**RE: RAM Terminals, LLC Coastal Use Permit Application
CUP Number: P20120190**

This letter is submitted on behalf of the Gulf Restoration Network, the Sierra Club, the Louisiana Environmental Action Network, and the Lower Mississippi Riverkeeper in regards to the application of RAM Terminals, LLC (“RAM”) for a Coastal Use Permit (“CUP”) for its proposed coal export terminal. After reviewing the letter that RAM submitted to LDNR on October 25, 2015 in response to LDNR’s request for additional information on September 25, 2015, it is clear that RAM has not and cannot adequately answer LDNR’s or the public’s questions as to the nature of their project, the economic need for the project, or its potential impacts. As RAM has not responded to repeated requests for this information, LDNR should deny RAM’s application for a CUP.

**RE: P20120190, Coastal Use Permit Application
RAM Terminals, LLC**

Figure 2. FLOW-3D Model of the RAM Terminal Facility Combined With the River Bathymetry and Proposed Diversion Channel.

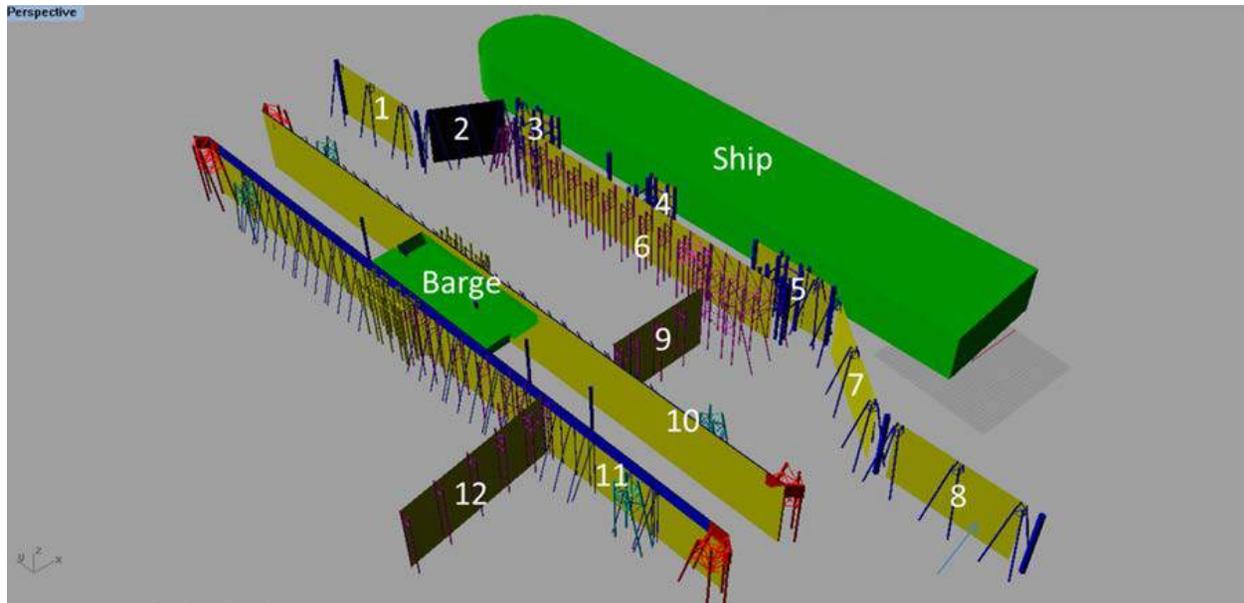
1. Figure 2 shows the presence and relative-size of the RAM facility near the intake of the proposed sediment diversion. Navigation concerns should be fully investigated to assess the potential impact on vessel traffic generated by the RAM facility with the presence of the cross-flow generated by the proposed Myrtle Grove sediment diversion. The investigation of navigational concerns was not part of the scope of the analysis presented here.
